NEW CASTER ADJUSTMENT

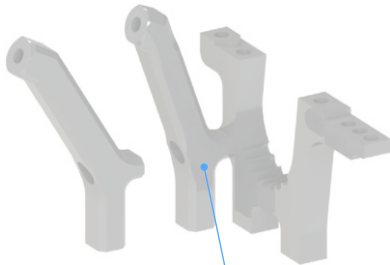
With a new caster adjustment system, the upper arm bracket can be moved back and forth, which is easier to adjust and prevents binding of the upper arm when making caster adjustments. Additionally, it gives a wider range of caster values.

SHOCK TOWERS included

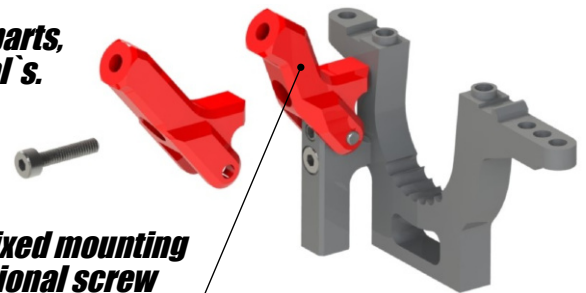
The new shock towers are lower, providing a flatter damper position. Active or fixed mounting can be chosen with the same parts, reducing the need for optional s.

Active or fixed mounting
by additional screw
(front & rear)

NEW DRIVE SHAFT'S included

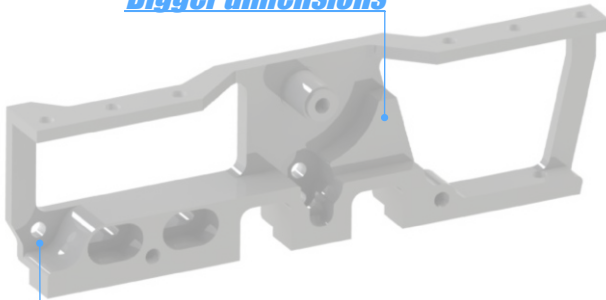
New drive shafts with ball bearings for reduced friction, reduced vibration and maximum reliability. New black wheel hexes provide a 100% straight mounting area.
